POLICY ISSUE
(Information)

SECY-85-258

Subject: THE STATUS OF ACTIVITIES UNDER THE NUCLEAR WASTE POLICY ACT OF 1982 (NWPA) AND OF DOE'S PLANS FOR THE FUTURE

SCHEDULE ESTIMATES FOR HLW REPOSITORY LICENSING

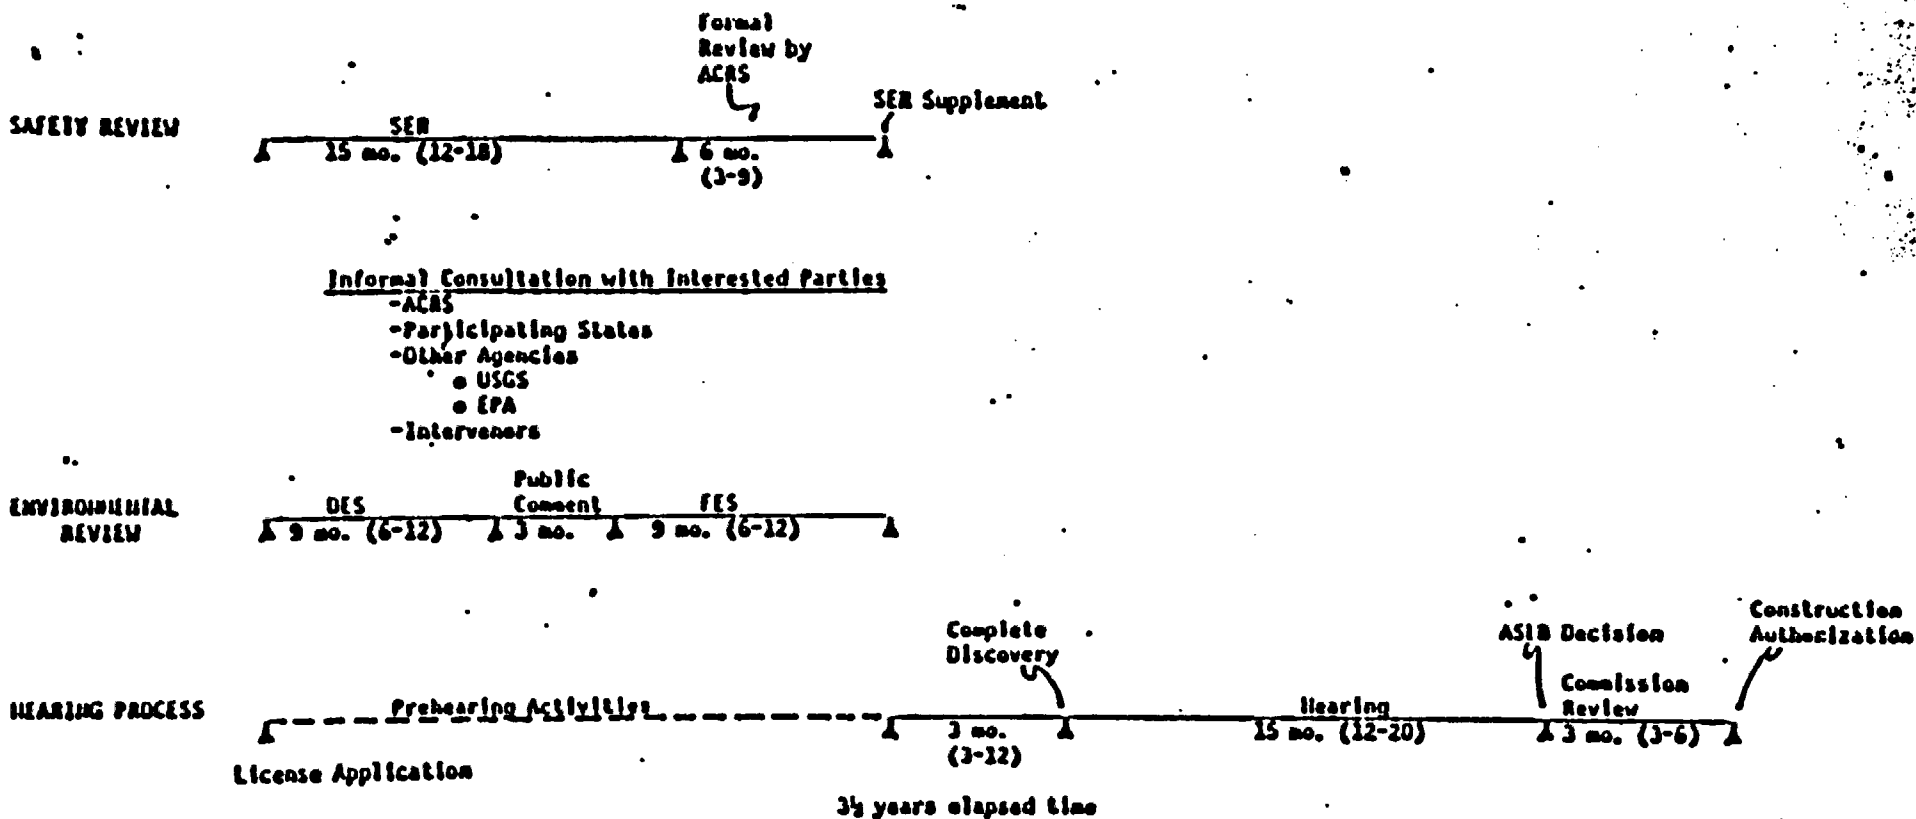
There are several very important assumptions supporting these estimates. First, a high quality and complete license application is assumed. The schedules are based on DOE having completed all of the technical work and testing needed to make the findings required in 10 CFR 60.31. However, as I indicated in my recent letter of April 15, 1982, we are concerned about whether your current plans for underground testing and site characterization will be adequate to result in a complete application.

The second assumption is that there will be a free and open exchange between the DOE and NRC to establish what information will be needed for the license application and that the NRC will be kept abreast of information and data as it is developed at sites being characterized. This is the kind of consultation called for by S.1662 (Section 404 (c)). In light of recent difficulties in scheduling discussions at the BWIP

Any use of this schedule by the DOE in its planning must include statement of the above assumptions. Until such time as our concerns are resolved, we are not sanguine about the prospects for the sort of orderly licensing proceedings that are depicted in the attached schedules.
